Subject: Ross Project Programmatic Agreement - Comments/Revisions from 11-14-13 Webinar
Sent Date: 11/15/2013 8:47:31 AM
Received Date: 11/15/2013 8:47:39 AM
From: Moore, Johari

DRAFT Appendix A – Undertaking and Area of Potential Effects

PROGRAMMATIC AGREEMENT
AMONG
THE U.S. NUCLEAR REGULATORY COMMISSION,
THE ADVISORY COUNCIL ON HISTORIC PRESERVATION,
THE WYOMING STATE HISTORIC PRESERVATION OFFICE,
AND
[THE U.S. BUREAU OF LAND MANAGEMENT,
STRATA ENERGY, INC., CONSULTING TRIBES, CROOK COUNTY MUSEUM
DISTRICT, ALLIANCE FOR HISTORIC WYOMING]
REGARDING
THE ROSS IN-SITU URANIUM RECOVERY PROJECT
IN CROOK COUNTY, WYOMING

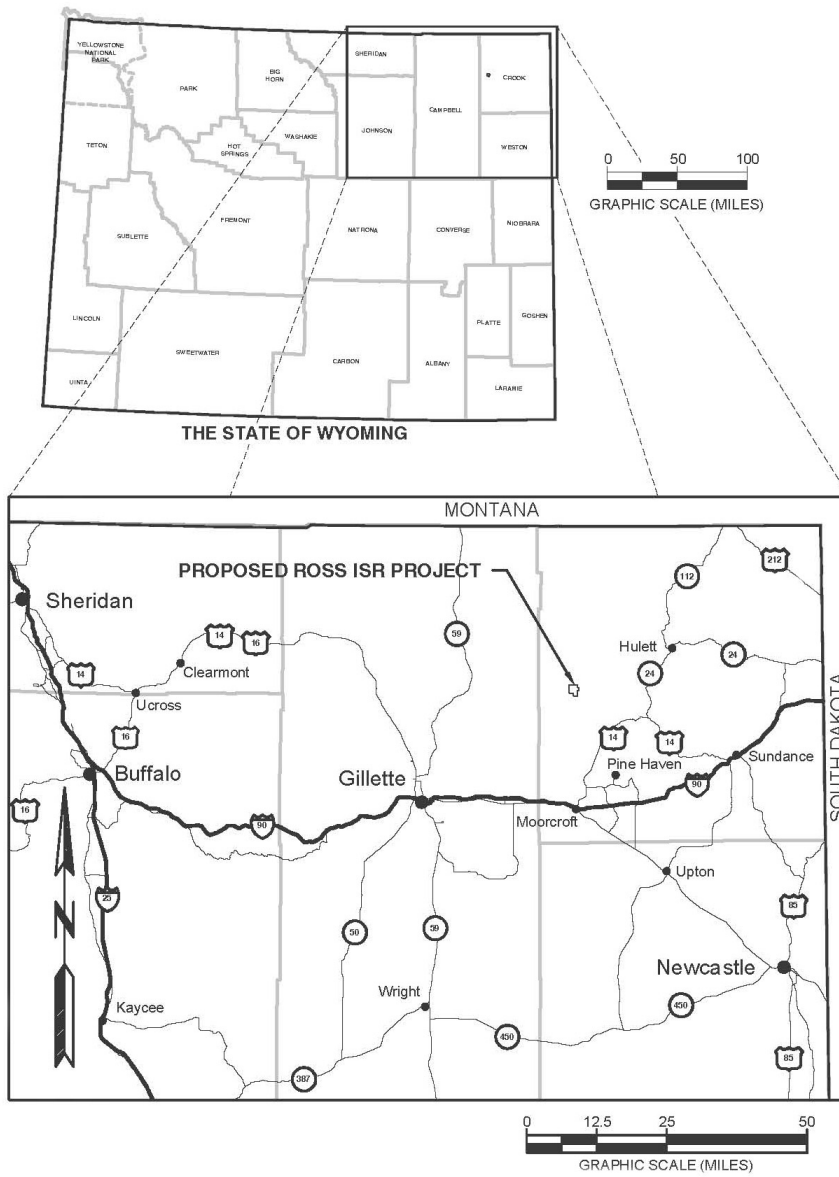
Comment [A4]: General license boundary and legal

Comment [A5]: Suggest area inside license boundary only for direct impacts and support with ER Figs 1.2-6 and/or 1.2-7.

Comment [A6]: This seems misplaced here, at least as written. Is the point that if there are no visual effects outside of the property boundary, the APE has appropriately been defined as the project boundary? What about noise and vibration? Any other indirect effects from the project that could potentially affect historic properties?

Figure 1-2 Ross Project License Boundary and Distribution of Land Ownership

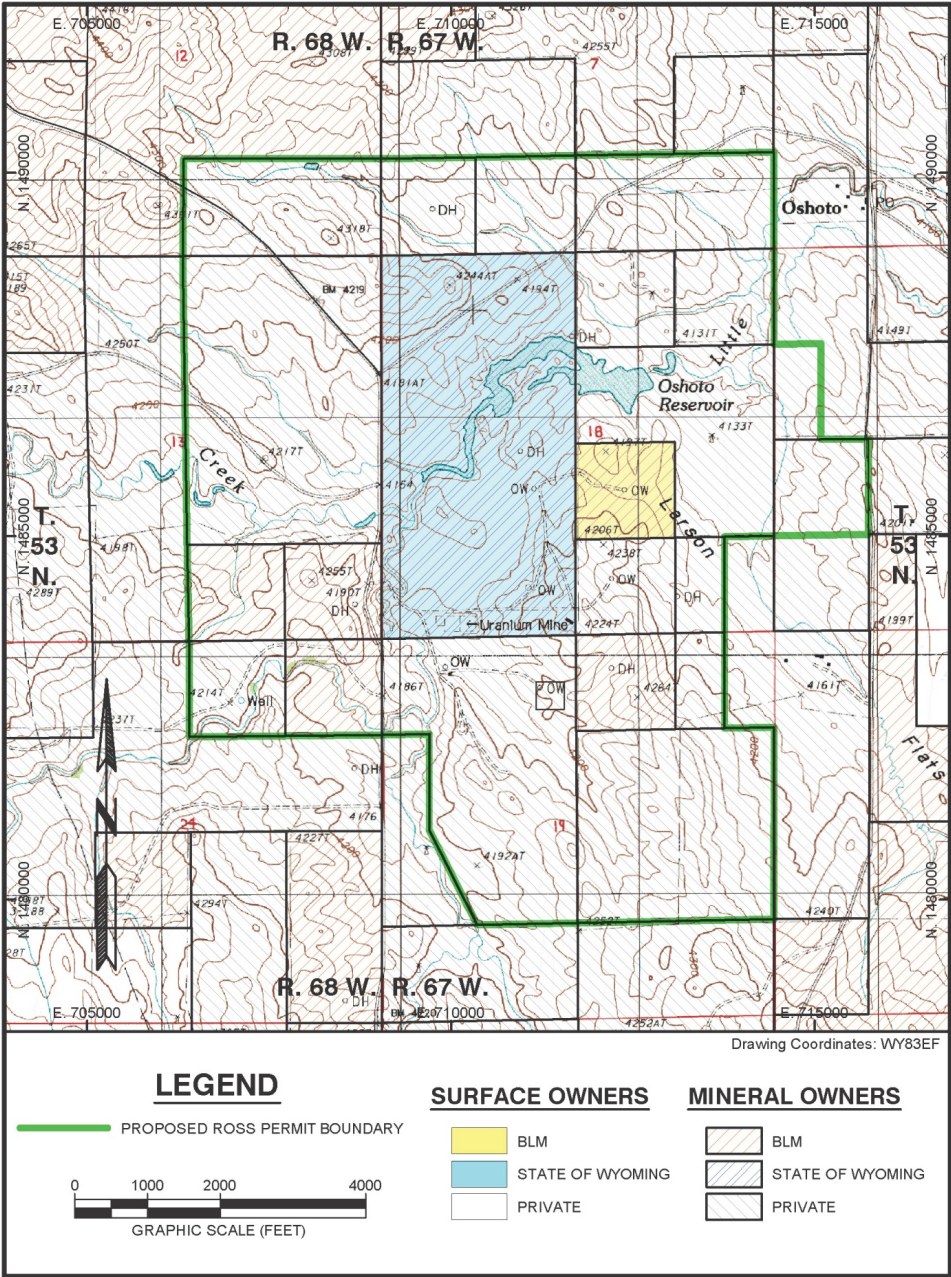
Comment [A2]: Section needs to reference Figs 1-1 and 1-2
